From: M. Junghans Project #: 12168.00

cc: David Stewart, Boston Properties Re: Ames Street Residences Article 19: Special Permit Project Review

Date: February 4, 2015

Response to Comments

Figure 13

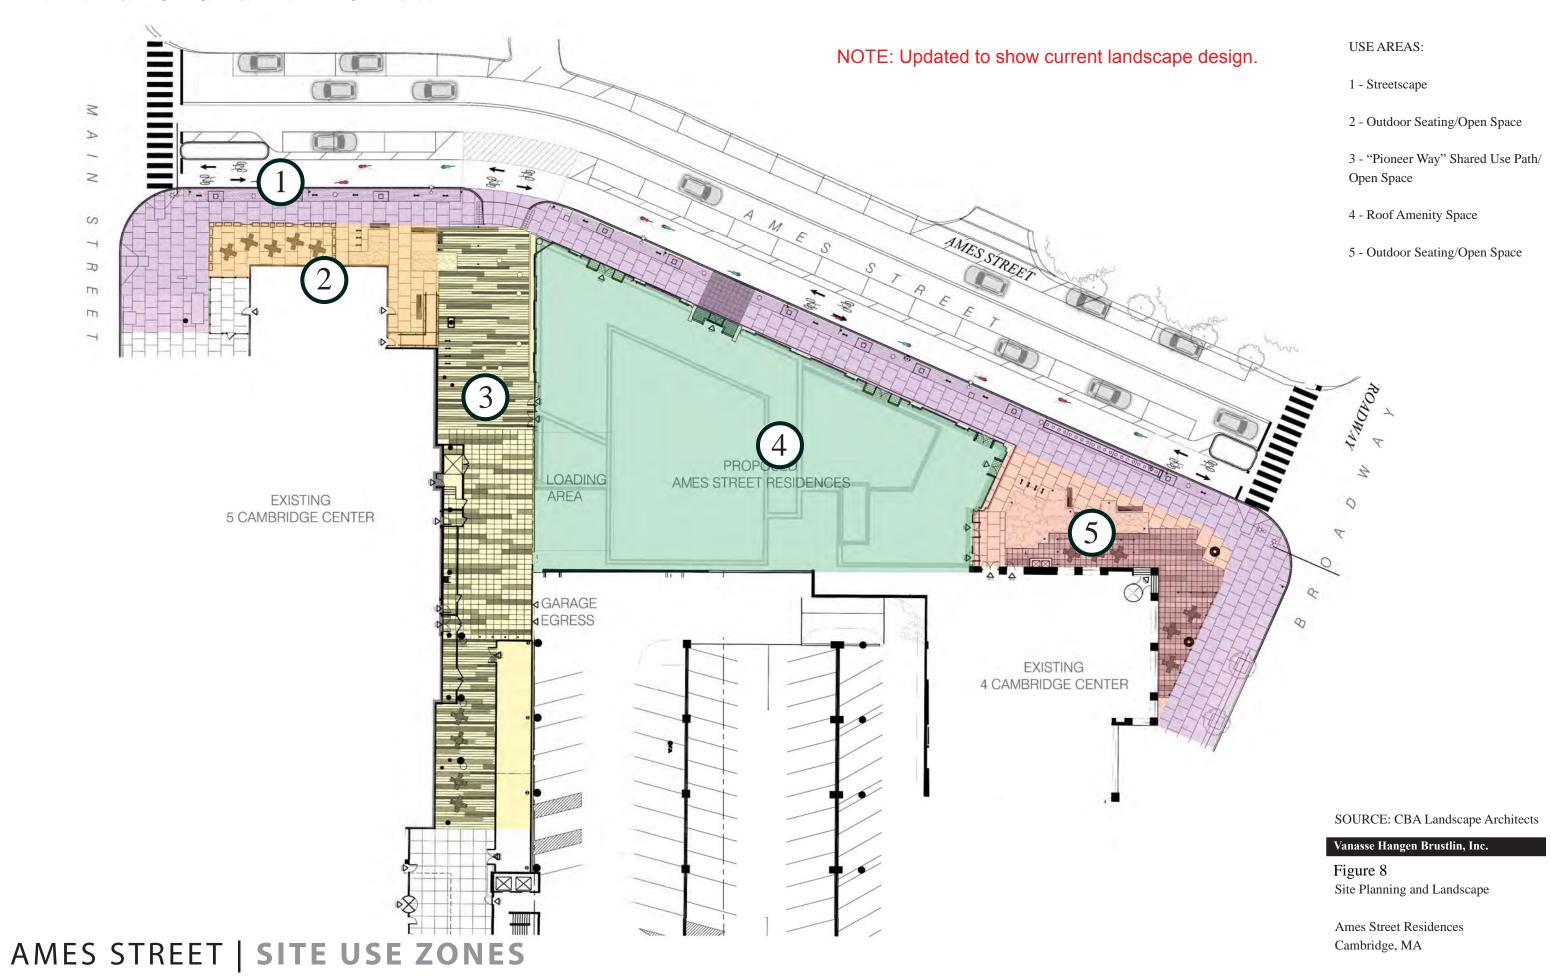
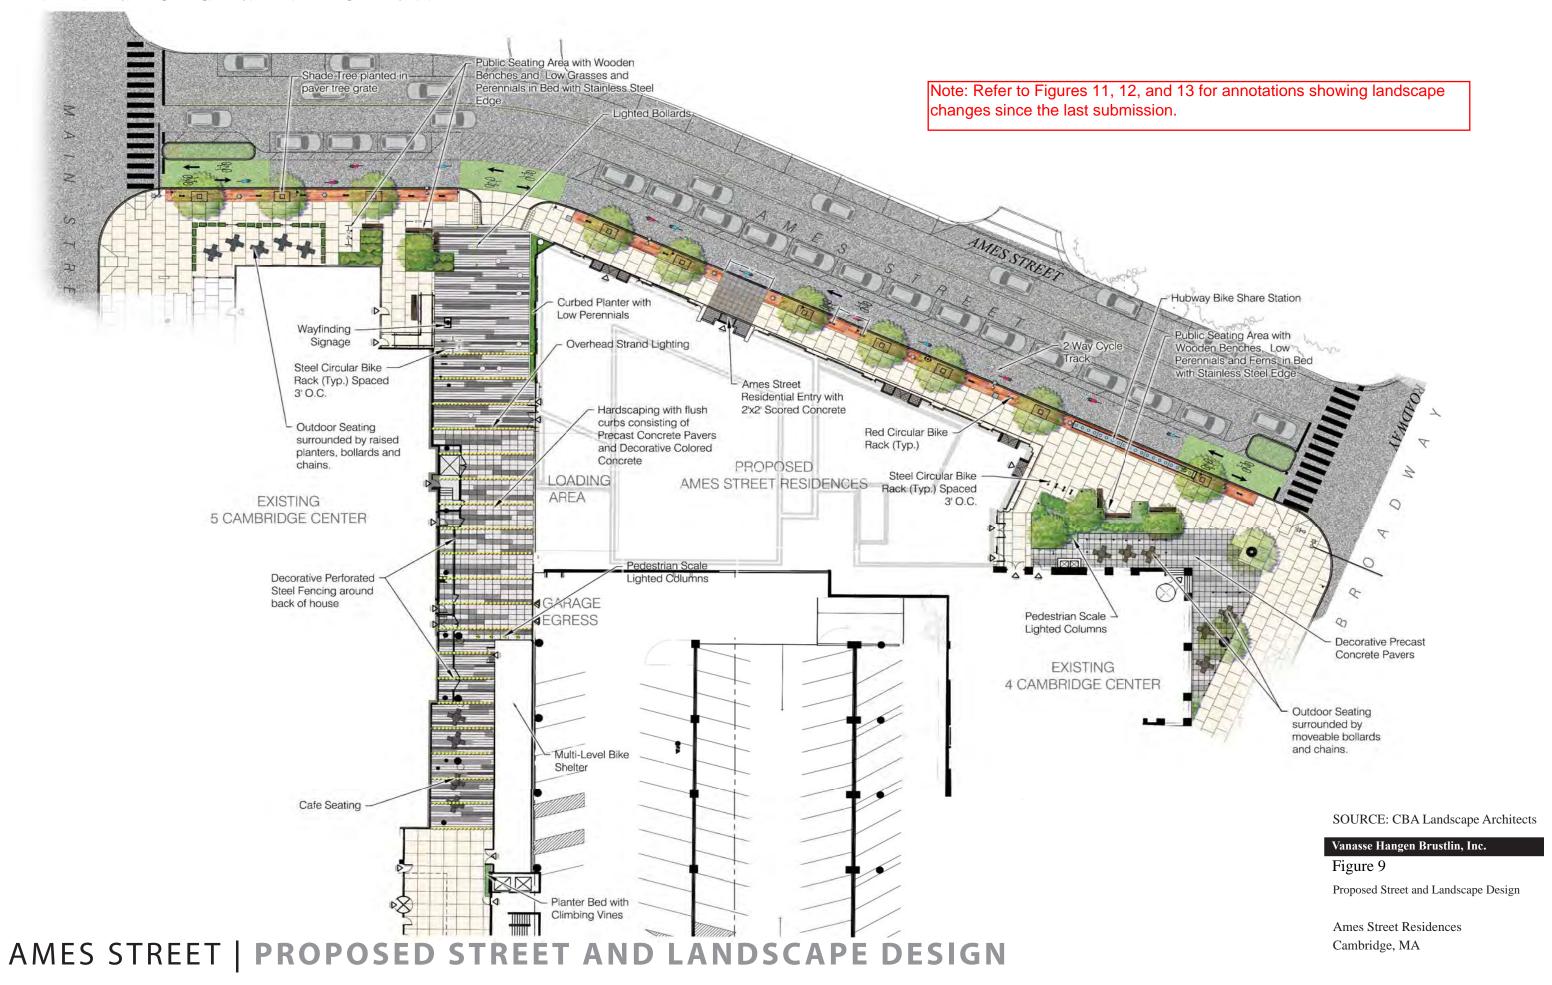
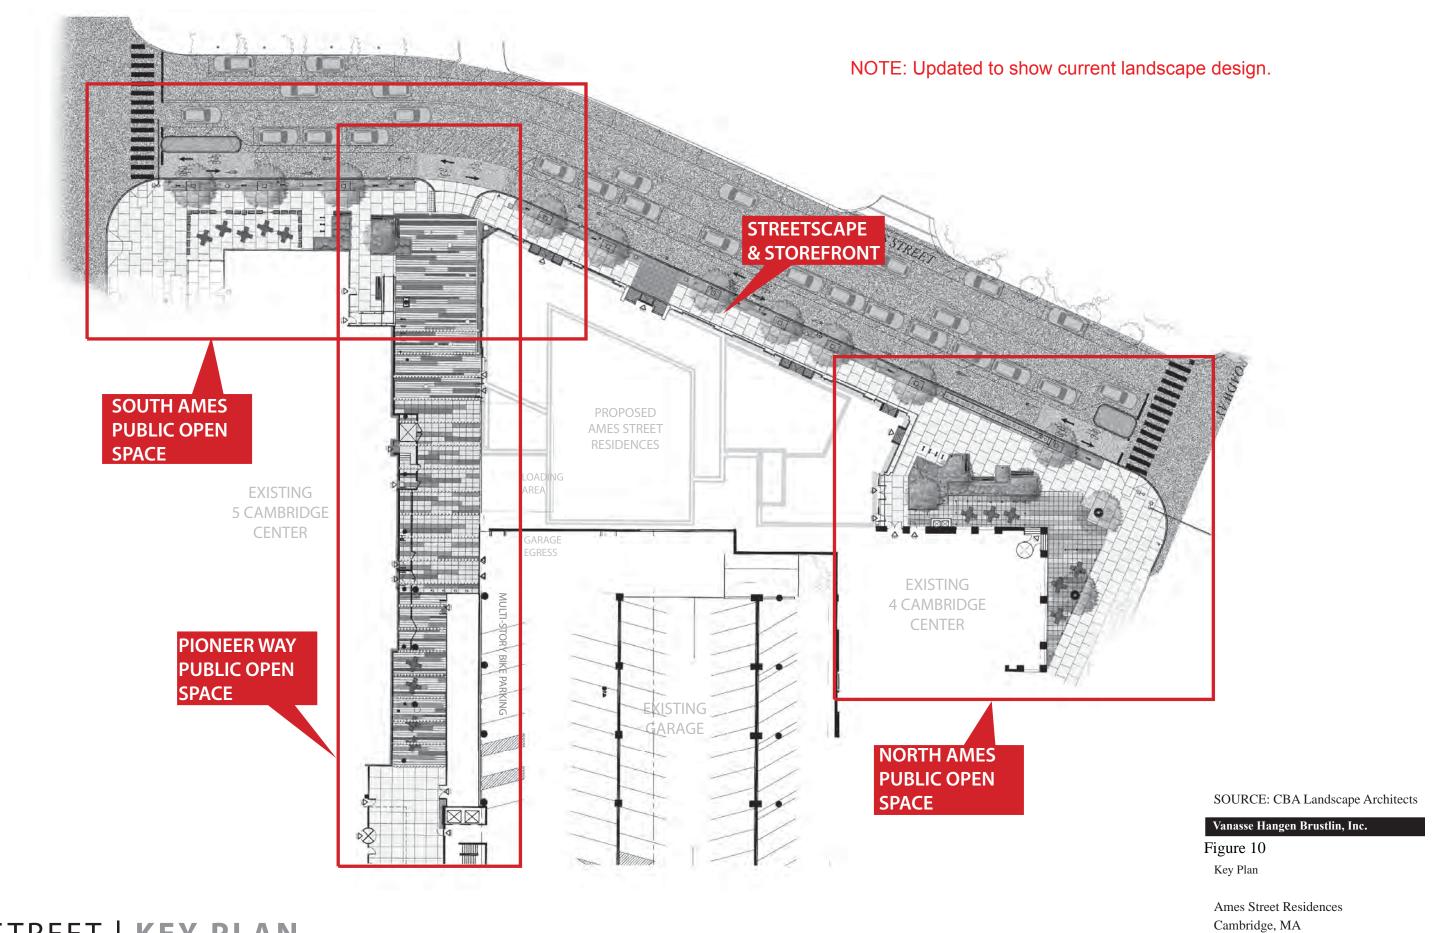
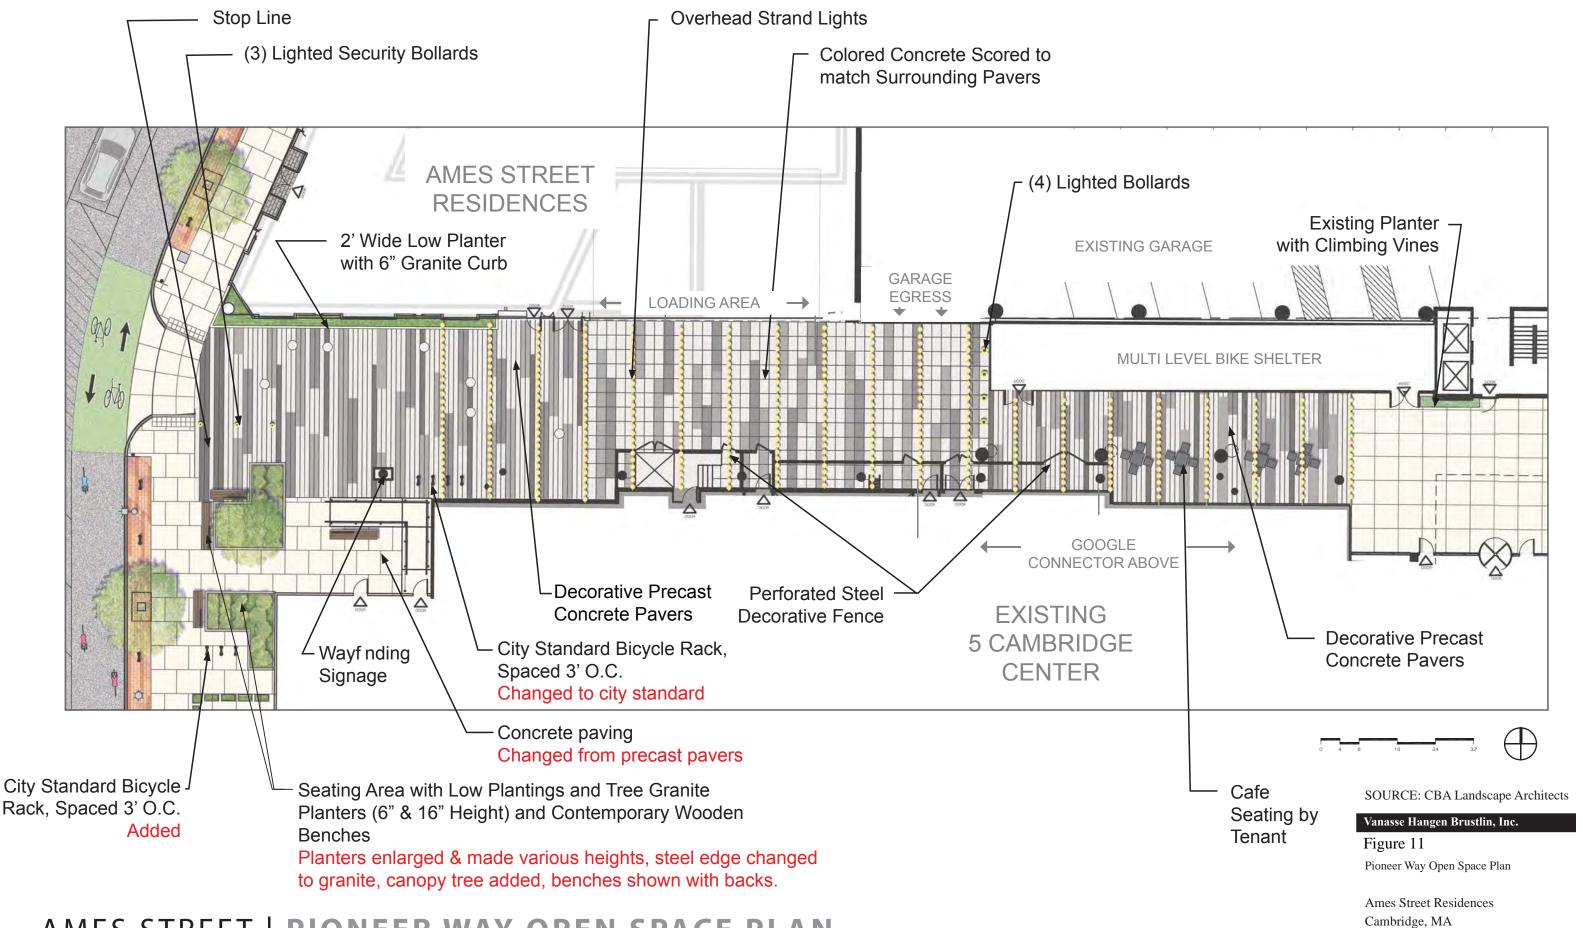
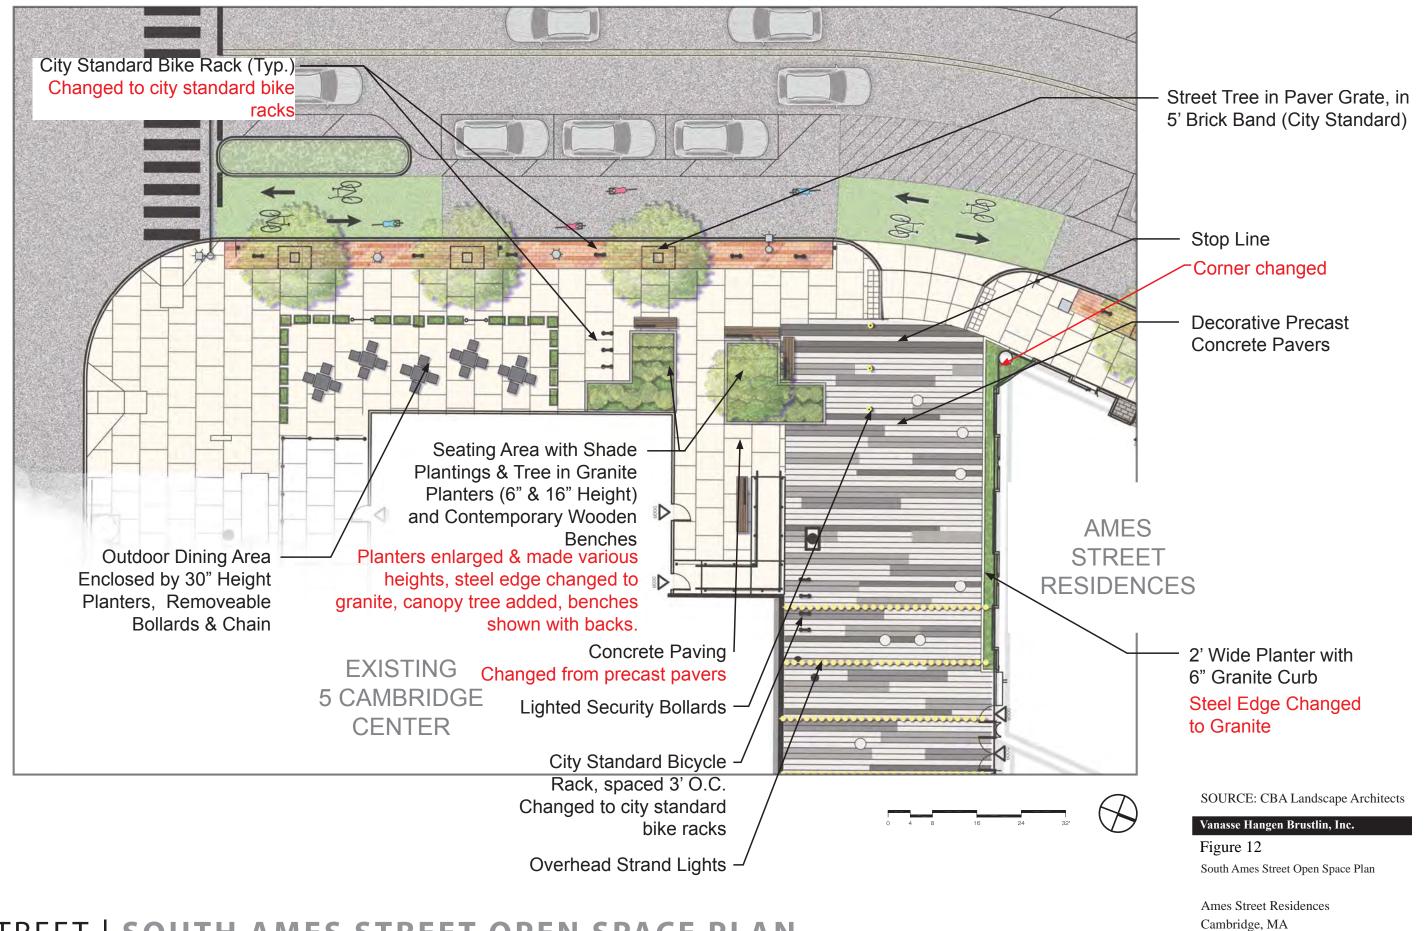
In addition to the cylinder lights currently shown on **Figure 13**, the design team is exploring possible art or other "dynamic" installations in the north pocket park. Such installations will be explored with CDD staff as the final design of the north pocket park is advanced.
